**DEFENSE NUCLEAR FACILITIES
SAFETY BOARD**

Staff Report

May 6, 2021

Savannah River Site H-Canyon Safety Basis Review

Figure 1. *Portable Air Compressor and Associated Equipment*

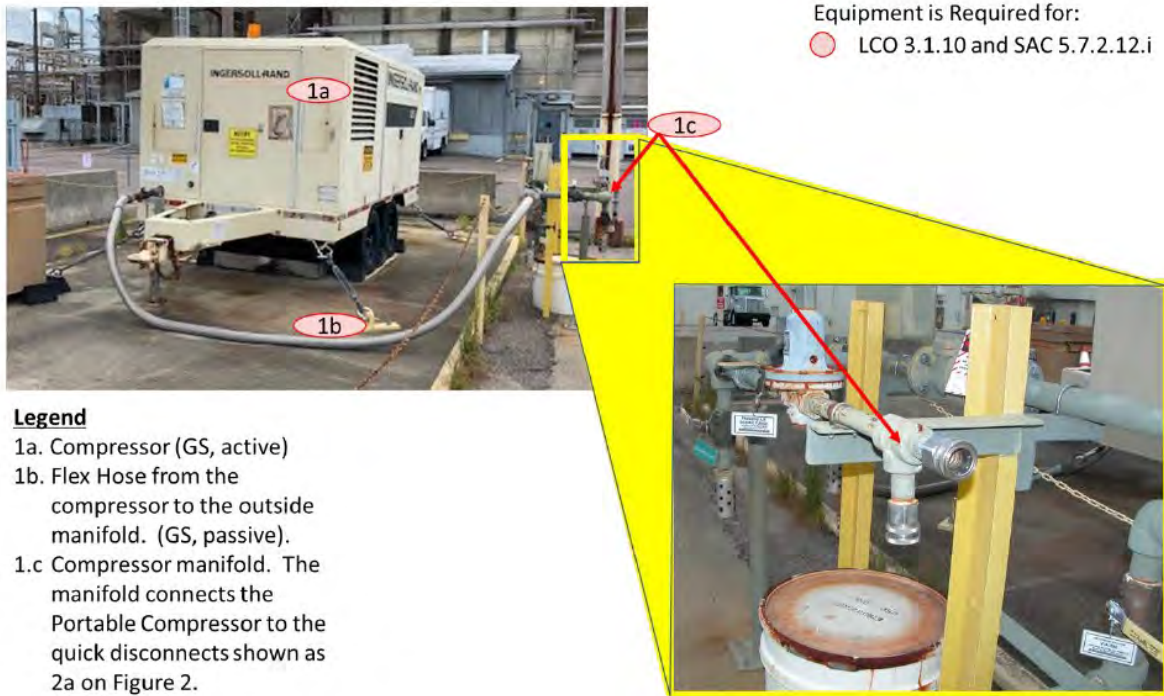
Inadequate Safety-Significant Designation—Flammable gases generated in the process vessels during normal operation are removed by the instrument air system. This system, however, is not seismically qualified. If the instrument air system compressors or headers fail during a seismic event, a portable air compressor with backup power supply is identified to provide compressed air for purging the vessels. A safety significant SAC is identified to perform this function: “Following a seismic event, the response to a loss of vessel(s) purge airflow provided by the instrument air system through the vessel liquid level jumpers shall be the connection of the portable compressed air to the required vessels at the liquid level piping to be purged and the operation of the equipment identified in LCO 3.1.10 to re-establish and maintain the required air purge.” “The safety function of the seismically qualified vessel air purge equipment/piping is to provide a flow path for the portable compressed purge air to the canyon vessels to maintain the flammable gas concentration in the vessel vapor space below the CLFL after a seismic event. The portable compressor/power supply and portable tubing are functionally classified as general service.”

The equipment that provides the passive air flow paths such as wall nozzles and piping, flex hose with quick disconnect, isolation valves and portable rotameter are identified as safety significant. The supplied air flow for the removal of flammable gases, however, is provided by a general service self-contained fuel operated portable air compressor, which is crucial to the function of the mitigative system. Failure to provide compressed air would deny the process vessels the purge air needed to remove the flammable gases; and could lead to a potential deflagration or detonation event with significant consequences to the co-located workers. The

- During the discussions with the site personnel, DOE and SRNS representatives stated that although the portable air compressor is not designated as safety-significant, it is maintained under a preventative maintenance program (e.g., oil changes) and is started on a weekly basis, which increases the likelihood of identifying operability issues. Although the TSR requires periodic visual inspection and functional test of the system, not all the surveillance and maintenance requirements are identified in the TSR document since the air compressors are not designated as safety-significant. It is important to note that the site reported seven failures for the three seismic portable air compressors during their routine start up tests since 2014, mainly due to failed batteries or failed starters, based on the data provided during the discussions.

- According to site personnel, there are three portable compressors available to service the 32 process vessels after an earthquake, providing purge air to each in the order of their time to reach CLFL. Some of these vessels are expected reach the CLFL in less than 24 hours based on the contractor's analysis. The contractor believes that availability of three such systems will increase the reliability of having the capability to purge the vessels, as they can be moved around when any one is found to be inoperable after an earthquake. However, two of these portable compressors would have to be towed (see Figure 1 below) some distance (hundreds of meters), with the travel path potentially obstructed by debris and downed power lines in a post-seismic condition, creating an unpredictable and unreliable environment in which any mitigating action must be taken.

- The DSA contains planned safety improvements, and states: "Use of a stand-alone, seismically qualified vessel air purge system has been proposed to improve the control strategy for preventing an accumulation of flammable gases in the headspace of the canyon vessels following a seismic event. This would be a preventive SS control for design basis seismic events. As an interim control, the H-Canyon vessel air purge response (also referred to as the Seismic Event Response Program) is credited with preventing an accumulation of flammable gases in the vessels following a seismic event." It is not clear what DOE's plans are for implementing this proposed improved safety strategy to strengthen the reliability of the system and the safety posture of the facility.

Figure 2. *H-Canyon Exhaust Tunnel Layout* [2]

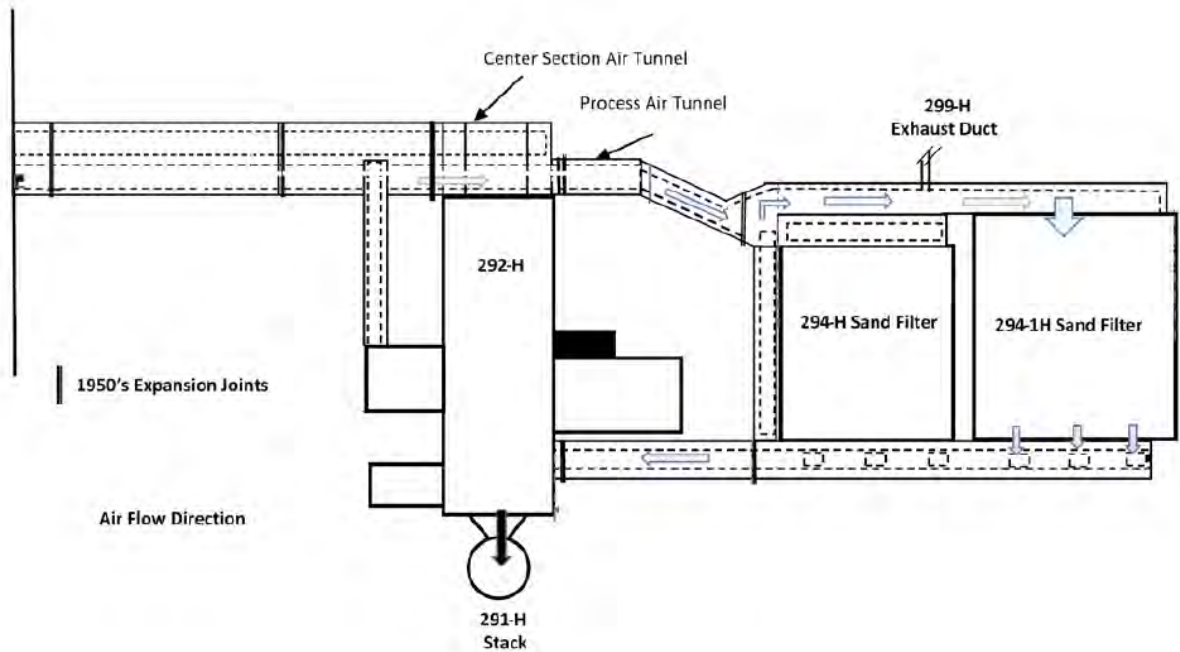
SRNS's analysis of the single and double tunnel configuration is technically defensible. However, if the tunnels are ever again credited to withstand the design basis seismic event, more sophisticated dynamic interaction analysis of the segments of the tunnels with adjacent facilities is needed. The fan house building, although a short and stout structure (i.e., essentially rigid from a dynamic perspective), would still be anticipated to impart inertial loads on the tunnel, particularly at the cross-over portion of the tunnel. Also, in this area the embedment of the tunnel is small and inertial effects may dominate over racking displacement loads. For the sand filter buildings, which neighbor significant lengths of the tunnels, complex soil-structure interaction response could be expected. These interactions would be between the sand filter structure, soil berms, the sand within the structure, and the neighboring tunnels; the current response of the sand filter buildings are based on simplified equivalent static methods.

The H-Canyon exhaust tunnels have experienced severe degradation in more than 60 years of use and this degradation will continue. DOE and SRNS should continue to monitor the condition of the tunnels and establish a firm timeline for both periodic re-inspection and eventual end of service. For the former, although the tunnels are currently credited as safety-class features for non-seismic events, the TSRs do not establish a required inspection periodicity of these design features. The TSRs do identify the SRS Structural Integrity Program as an administrative control; however, given that the tunnels are credited as safety-class for non-seismic accidents, an enforceable requirement for inspection periodicity is warranted.

A rigorous monitoring program is needed to not only observe degradation, but also detect wall movements that could be an indicator of the start of tunnel failure. This is particularly important since the current static analysis of the degraded tunnels [8] shows no margins for the code-based evaluations of ACI 349-13, *Code Requirements for Nuclear Safety-Related Concrete Structures* [9]. The staff team understands that three dimensional scans of the tunnels are planned, which will help supplement visual examinations and provide indications of worsening conditions. Based on the difficulties encountered during past remote inspections, future monitoring should include strategies to observe portions of the tunnel that are more difficult to observe, such as those obstructed by ductwork or hidden by tight corners. Lastly, since the static analysis of the tunnel indicates no margins when compared to code capacities, the staff believes SRNS should continue to enforce traffic restrictions over the tunnels to prevent unnecessary loading.
